**CITY OF CEDARBURG  
A MEETING OF THE PLAN COMMISSION  
MONDAY, FEBRUARY 2, 2026 – 7:00 PM**

- C. Public hearing, discussion, and possible action on the request of applicant DSDH Gerb LLC, in c/o Dave Herbeck of Herbeck Development, for Conditional Use Permit approval to develop a 16,617 sq. ft. motor vehicle collision repair facility on the vacant, 1.84-acre, M-2 General Manufacturing zoned site located at the northwest corner of Sommerset Avenue and Pioneer Road. The property owner is Pioneer Real Estate Development LLC in c/o Mike LaRosa.

# PLANNER REPORT

**1 EAST ELEVATION**  
SCALE: 3/16" = 1'-0"

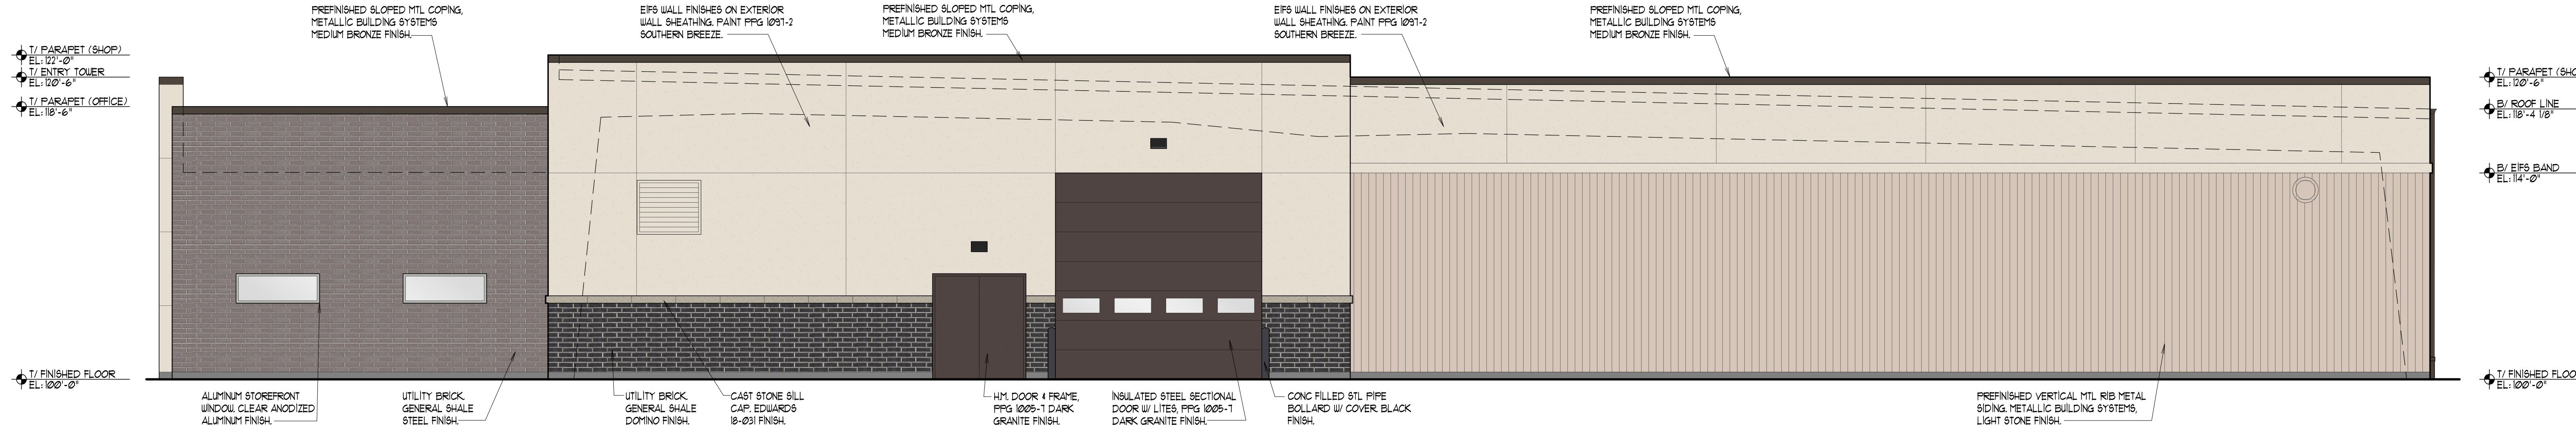
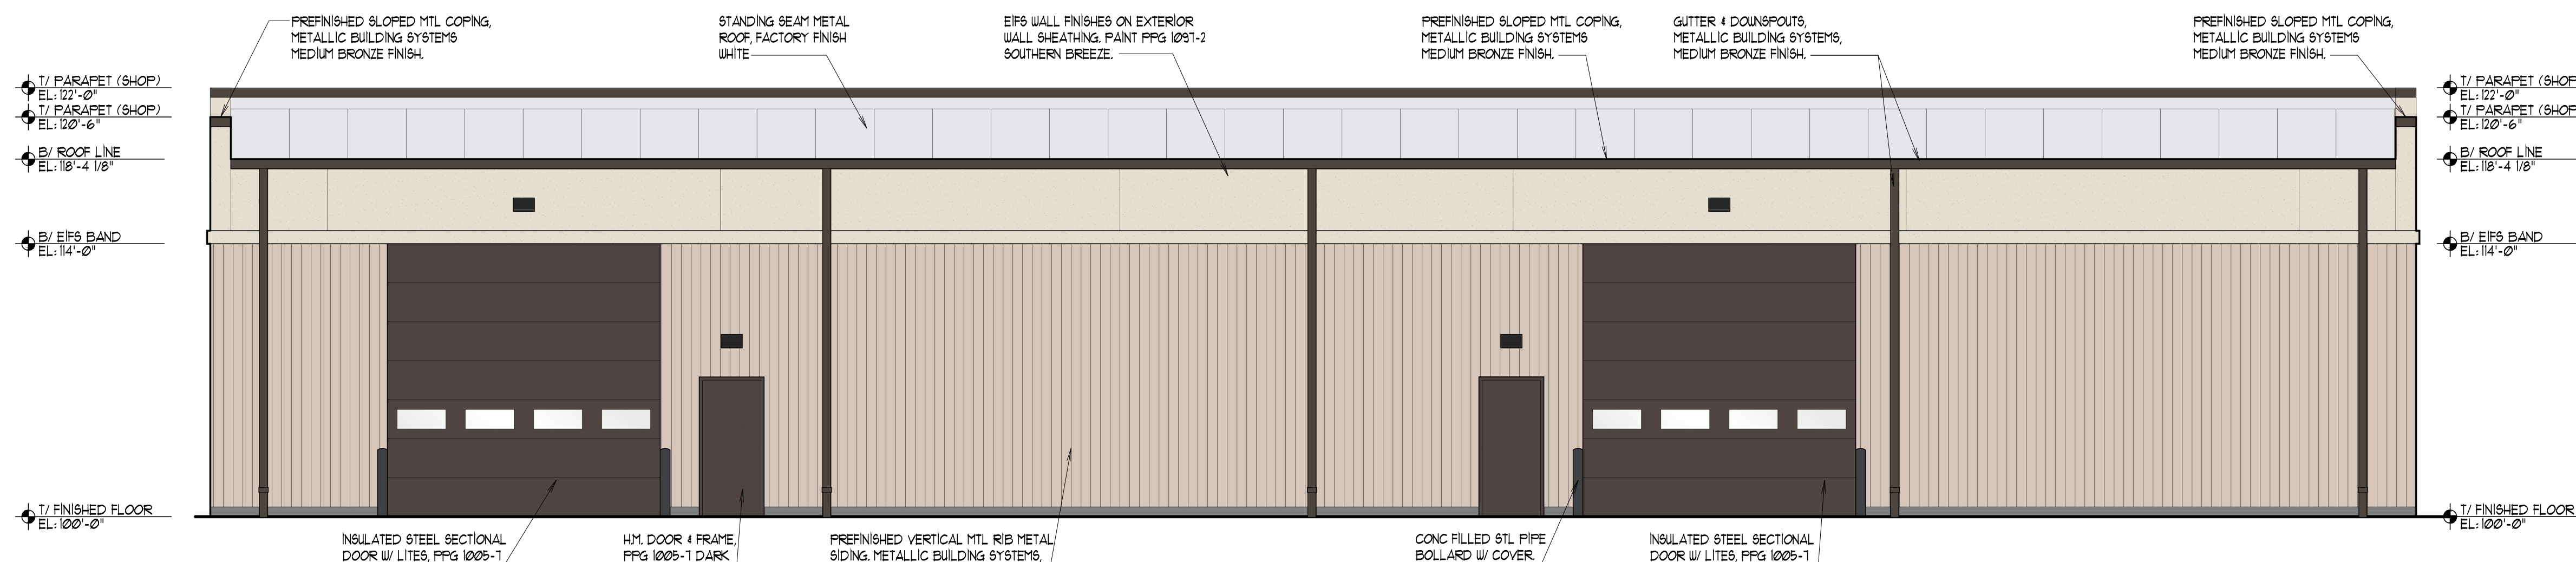
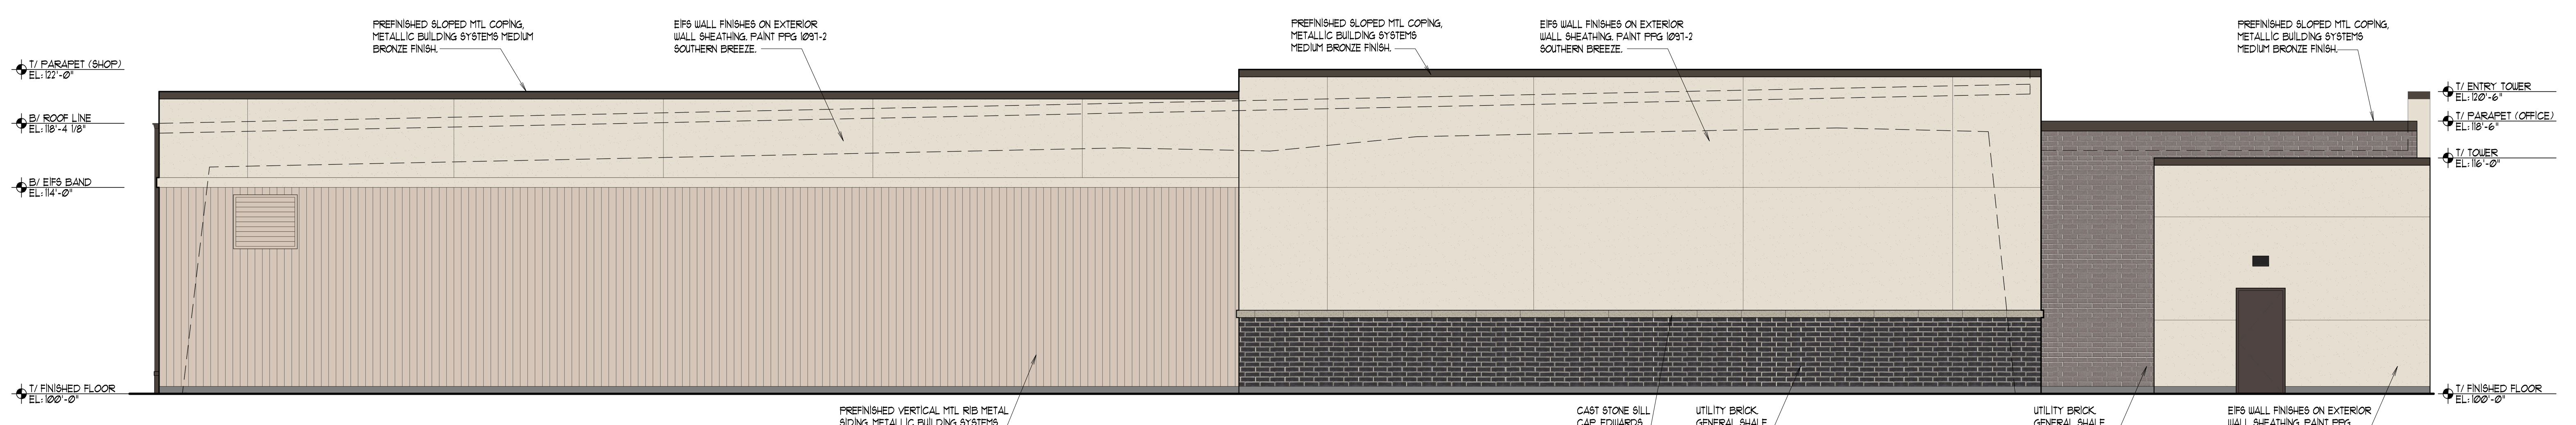
12) Applicant to consider the implementation of signage or other forms of architectural treatment on the southern façade of the building east end to break-up its somewhat plain presentation. Revision subject to review and approval by City Planner.

13) The rooftop equipment, typically rather intensive for an auto repair facility with paint booths, shall be fully screened from the surrounding view. The plan for this screening shall be subject to review and approval by the City Planner prior to installation of the HVAC. Applicant shall choose the least tall version of HVAC for the job as not to require excessive sized rooftop screening devices.
